**Allentown Historical Architectural Review Board
FINAL Review Sheet**

HDC-2024-00018

Address: 1515 Linden Street

Proposal: Reconsider window replacement on bandshell at West Park

Window Condition (Applicant)

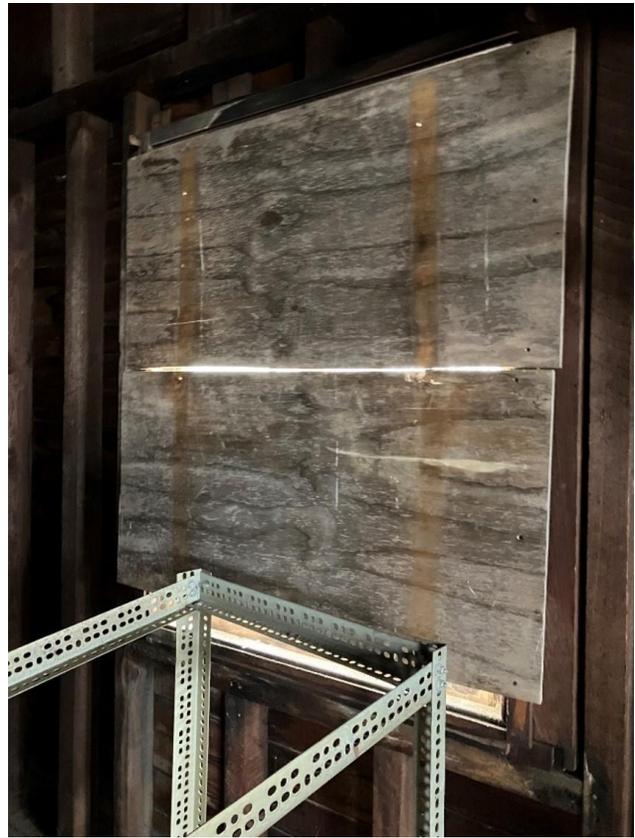
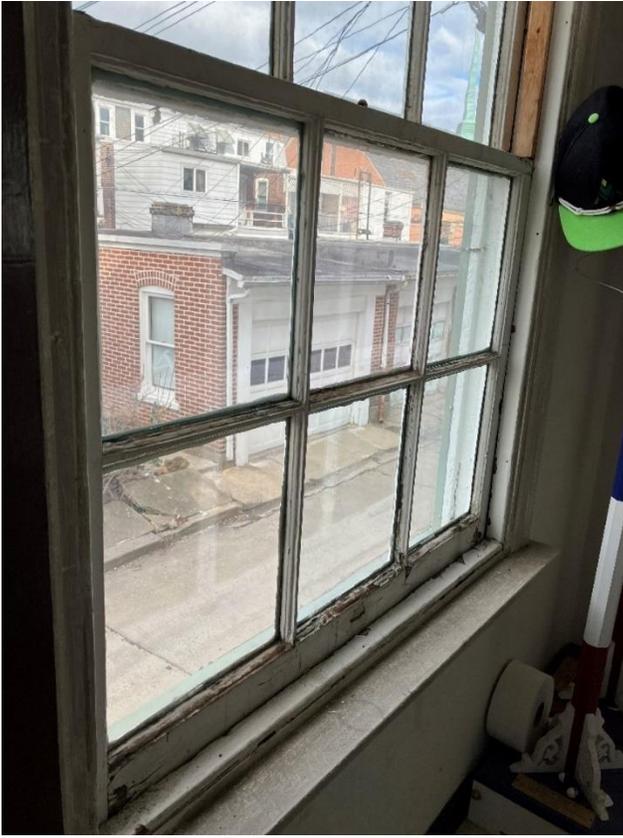
View: West side of the building in alley, first floor; window is damaged, doesn't work.

View: West side of building in alley, first floor; window doesn't work, gaps at the bottom, broken pulls.

Observations & Comments: Based on the review of the new photographs provided, it does not appear that the condition of most of the windows are beyond feasible repair – they range from potentially needing hardware replacement, wood repair, glazing putty replacement, and/or painting. That being said, given the request for reconsideration, there may be conditions not evident through photographs that warrant replacement over repair. As discussed in the March 4, 2024 meeting, replacement with the proposed aluminum clad windows with exterior applied muntins would be historically appropriate as long as the replacement windows do not reduce the daylight opening or sightlines of the original windows. Additionally, for increased durability and protection against vandalism, installing storm windows with either acrylic or polycarbonate on the exterior of the windows would be appropriate, as opposed to a metal mesh.

- The existing wood windows will be replaced with aluminum clad windows with exterior applied muntins to match the original window configuration.
- Polycarbonate or acrylic security panels will be installed over the windows with exterior stops screwed into the window frames.
- No wire mesh will be installed over the windows.
